ECE/TRANS/WP.29/GRSP/2007/14  
28 September 2007

REGULATION No. 29  
(Cabs of commercial vehicles)

Proposal for draft 03 series of amendments

Submitted by the expert from the Russian Federation<sup>\*/</sup>

Figure 1. Front impact test (test A)

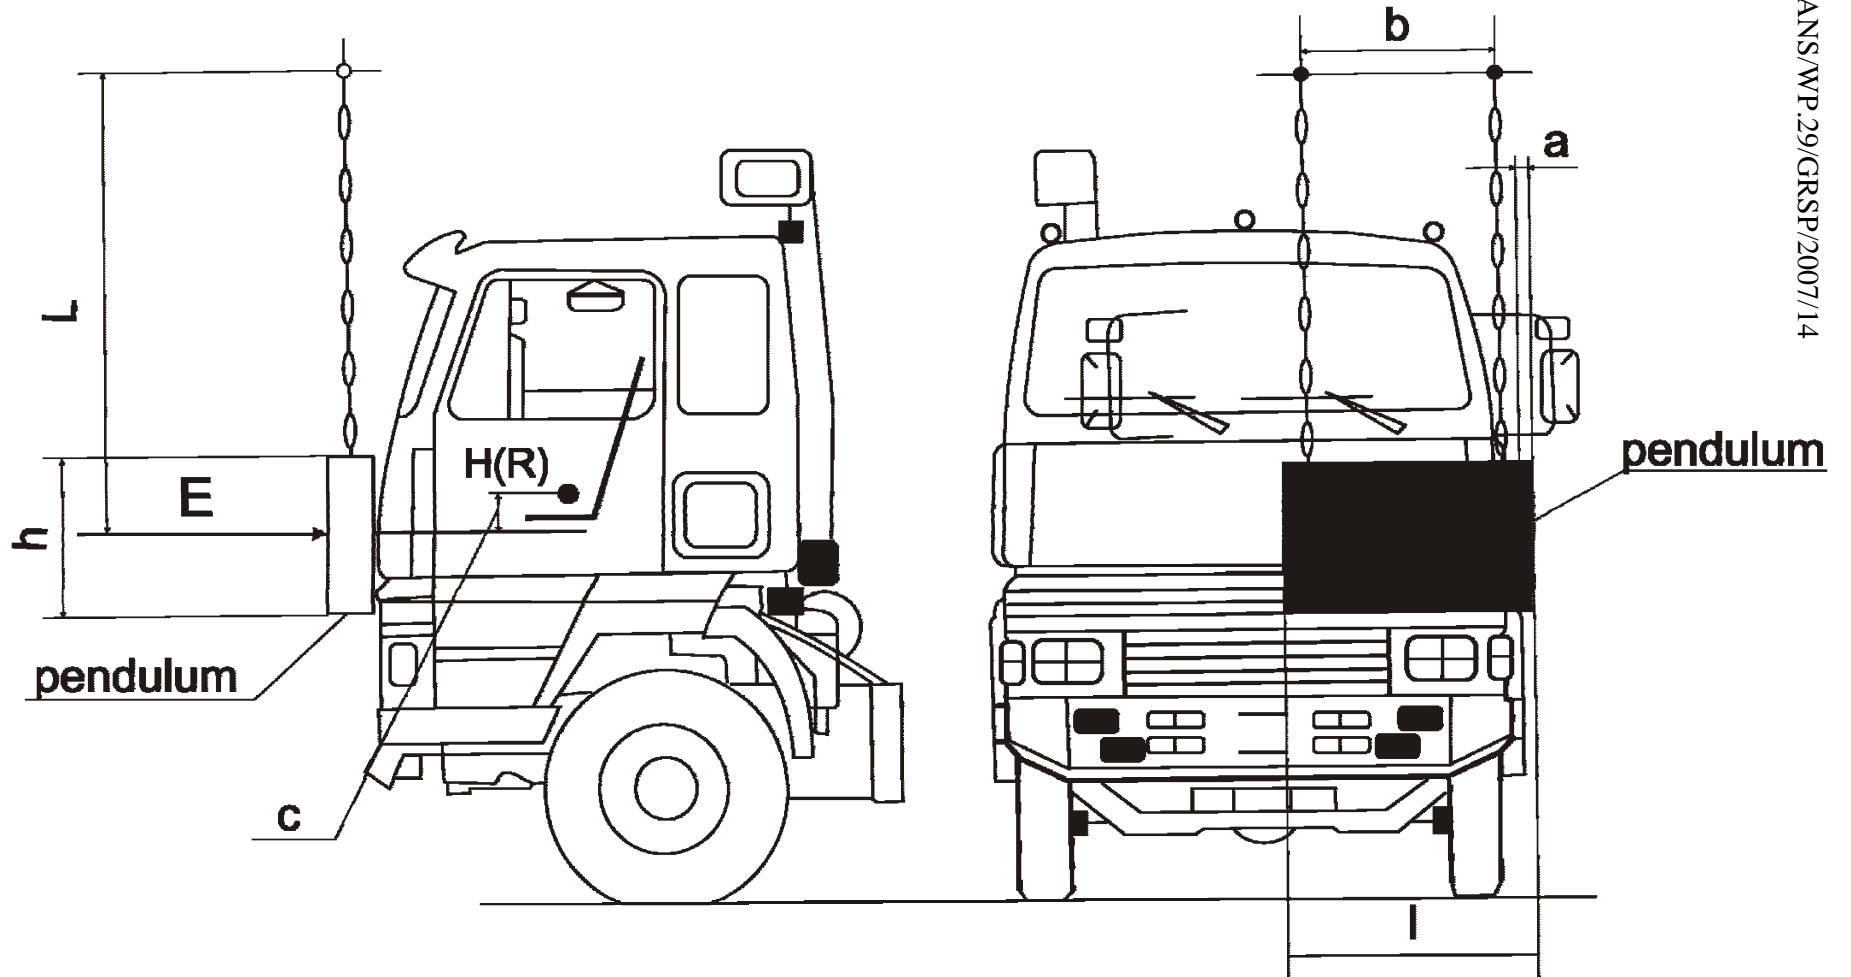
4.2.1. **The swing-bob shall strike the cab at the front in the direction towards the rear of the cab. The direction of impact shall be horizontal and shall be parallel to the median longitudinal plane of the vehicle (figure 1). The impact energy shall be 40 kJ for vehicles of the category  $N_2$  with permissible maximum mass**

over 7,500 kg and N<sub>3</sub>, 25 kJ for vehicles of the category N<sub>2</sub> with permissible maximum mass less than 7,500 kg and 15 kJ for vehicles of the category N<sub>1</sub>.

Figure 2. Roof strength (test B)

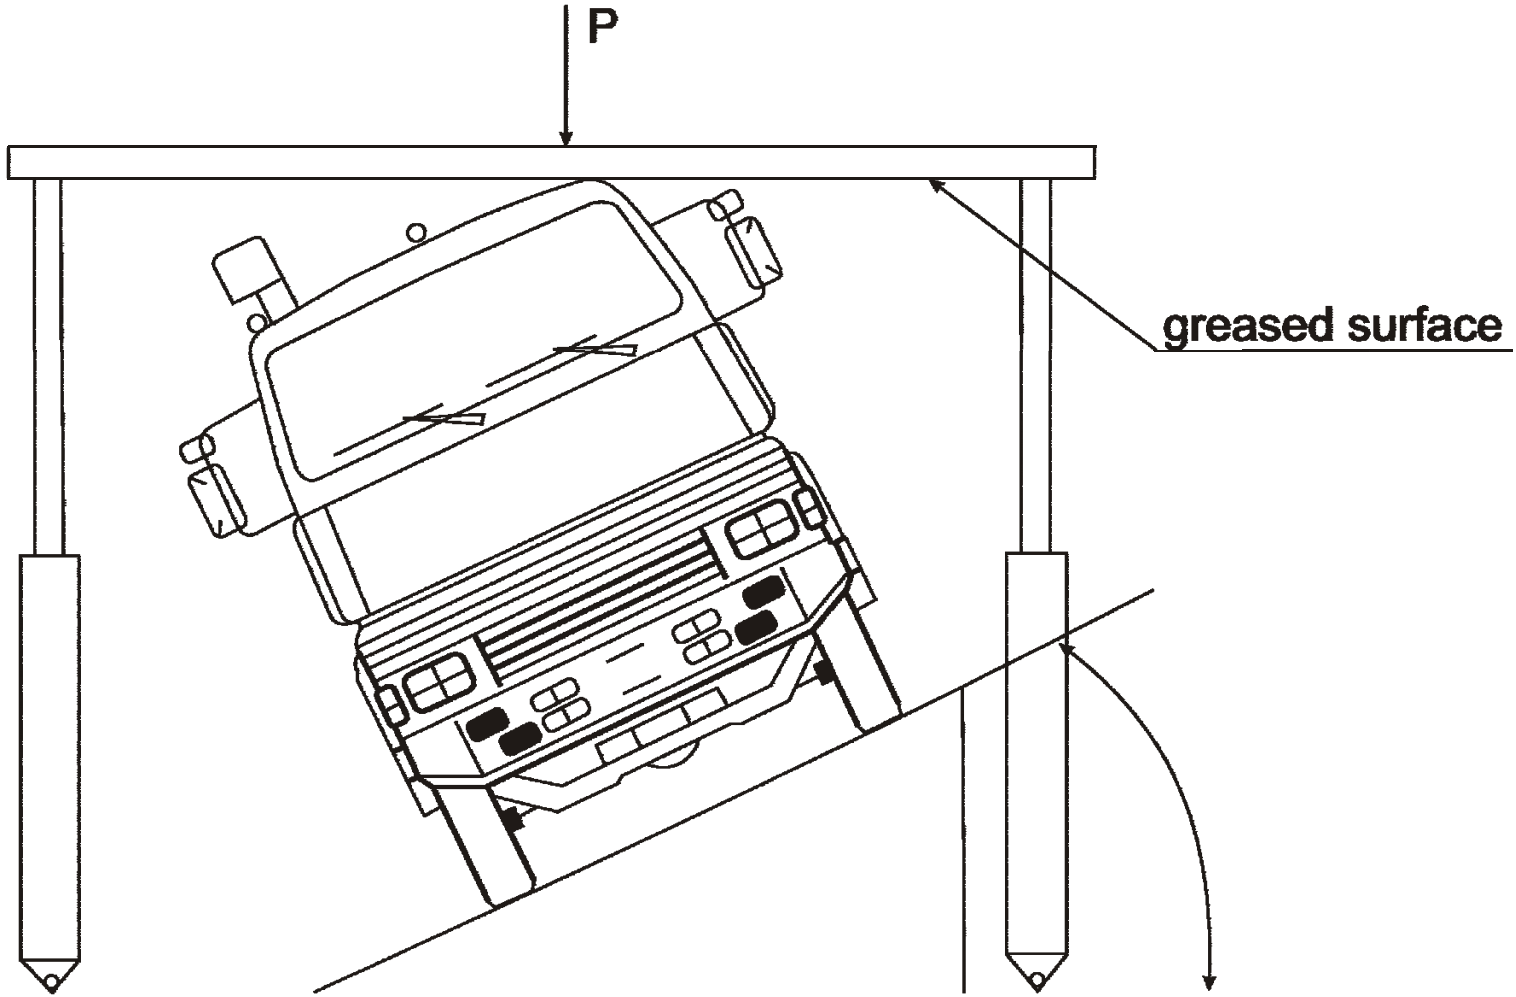
5.1.1. The cab shall be angled to 25 degrees in relation to its longitudinal axel. A driver's side of the cab shall be higher than the other one (figure 2).

5.1.2. The load shall be applied via a rigid slab with the corresponding configuration. Its lower side shall be evenly covered with a lubricant.

5.1.3. The roof of the cab shall withstand static load (P). The load shall be measured by the following expression:

in which: P<sub>CH</sub> – weight of a vehicle in running order, on forward axel;  
K - coefficient of dynamic load equal 2,5. The maximum load the roof of the cab shall withstand shall be not more than 10 t.

Figure 3. Rear-wall strength (test C)

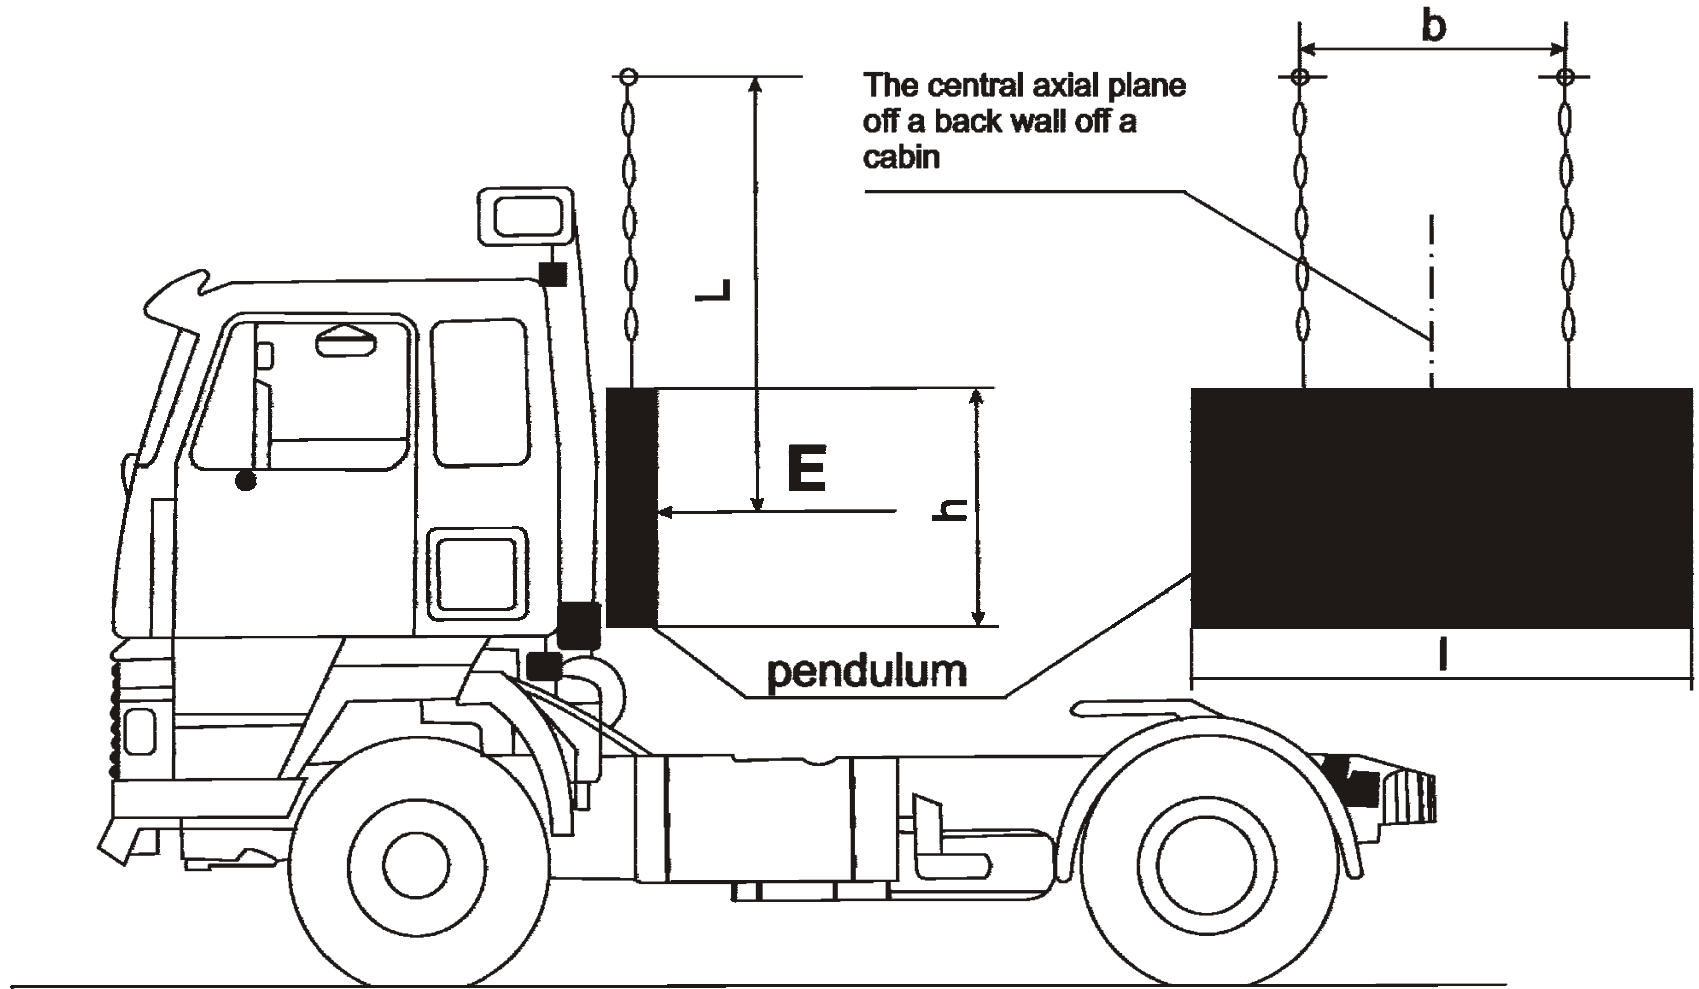
- 6.2. Test procedures**
  - 6.2.1. The swing-bob shall strike the cab at the rear in the direction towards the front of the cab (figure 3). The direction of impact shall be horizontal and shall be parallel to the median longitudinal plane of the vehicle. The center of the impact shall match the central axial plane of the rear side of the cab and shall be situated in the centre of the rear between the roof and the floor of the cab. The impact energy shall be 40 kJ for vehicles of the category N<sub>2</sub> with permissible maximum mass over 7,500 kg and N<sub>3</sub>, 20 kJ for vehicles of the category N<sub>2</sub> with permissible maximum mass less than 7,500 kg and 10 kJ for vehicles of the category N<sub>1</sub>.**
